Note

Since September 1981 a preglow time relay with modified ventilation is installed for quick-start preglow system. The part number has not been changed.

5-pole coupler
A 1st version
B 2nd version

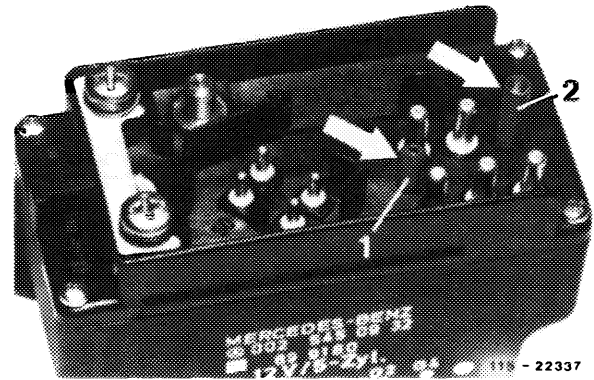
The modified preglow time relay can also be installed in vehicles prior to September 1981. In such a case, the modified 5-pole coupler must also be installed, since otherwise moisture may enter the relay.

Upon installation of the new relay, convert coupler of harness to new ventilation.

Modified preglow time relay
1 Ventilation
2 Higher coding pin

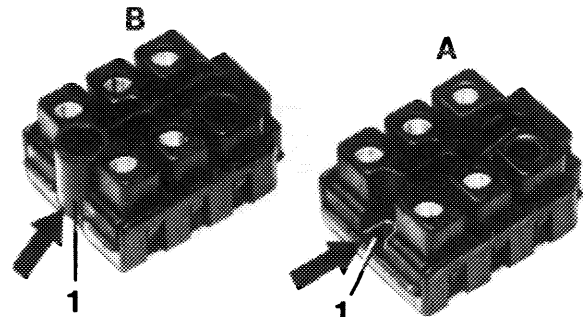
In the modified version of the preglow time relay, ventilation proceeds via coding pin (1). The coding pin (2) is also longer as before and the 5-pole coupler has been designed in such a manner that the ventilation is covered. In the former preglow time relay ventilation proceeded through a bore in housing.
